# Downtown Design Review

Project Name: **13<sup>th</sup> & Cherry Apartments**

Project File Number: **20-4706**

### Design Review Application Checklist

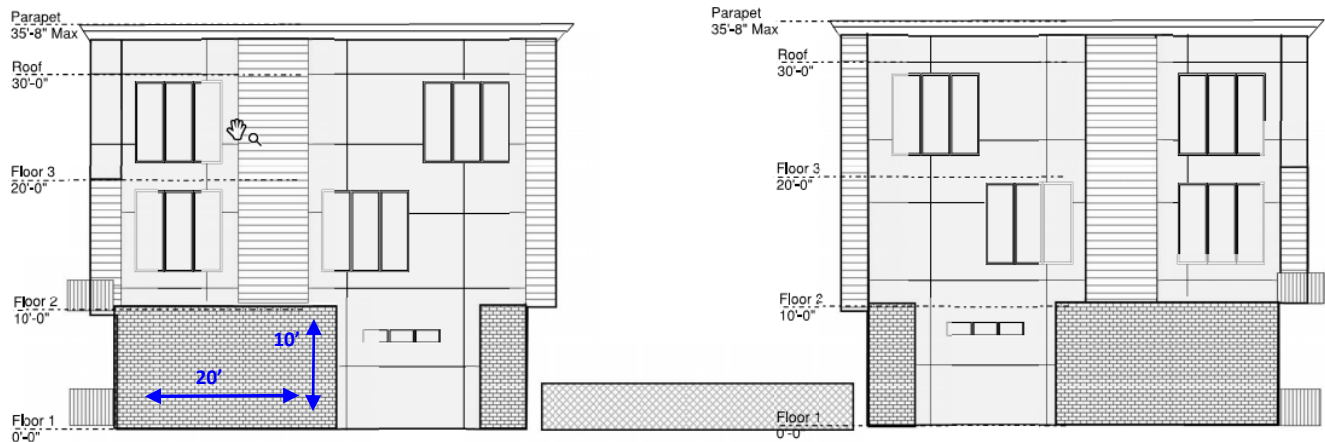
If cement board paneling and siding are planned to be the primary or secondary materials, the paneling or siding joints must be arranged consistently with windows, balconies, and modulated building planes, and the paneling or siding must be enhanced with façade details that add visual interest from the ground level and adjacent buildings. Compliance with this requirement will need to be clearly demonstrated in the detail-level architectural plans.

- Add details around all windows. See also OMC 18.120.450.

- Arrange joints and panel detailing consistently with windows, balconies and building modulation.
